Lake Shore Boulevard Design Review Marquette, MI

September 2, 2014
12035.200

Lake Shore Boulevard Design Review

Prepared for
City of Marquette

Figure 4.5 Armor layer geometry (Figure 3.25, CIRIA 2007)

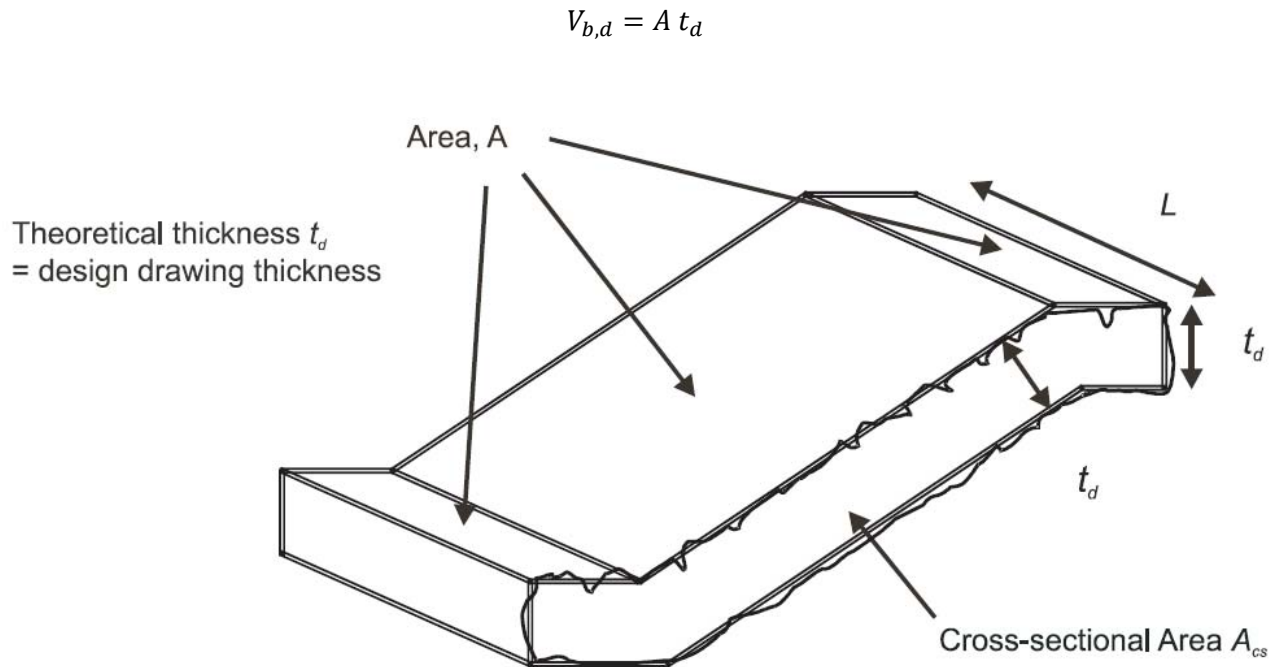
The calculated layer thickness for the underlayer appears to be acceptable. However, the stone size could be noted on the drawings in order to provide clarity.
